# # 24-6522

## **ALL ELECTRIC START 650'S** **ERRATIC STARTER ENGAGEMENT**

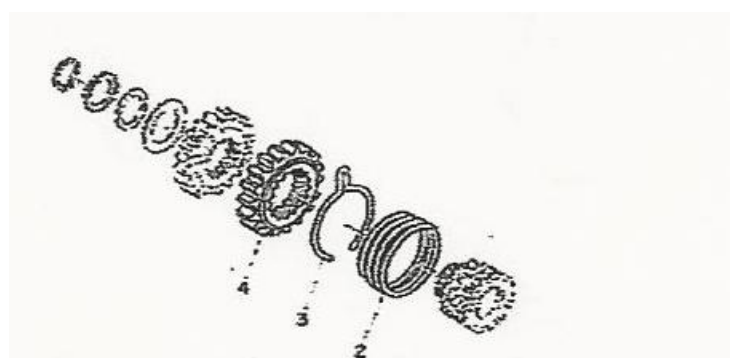
Erratic Electric Starter Engagement and Disengagement on Yamaha 650 Twins is often the result of the improper functioning of the three parts described below. Replacement of these parts with the indicated improved parts (only as set), will generally cure erratic engagement problems.

The clip (wishbone shaped spring) position is changed as shown below

Note: These parts are standard XS650 parts. They may be used as a set on all 650 Yamaha Twins with electric starters. Parts contained in kit #24-6522 replace all earlier versions of these parts.
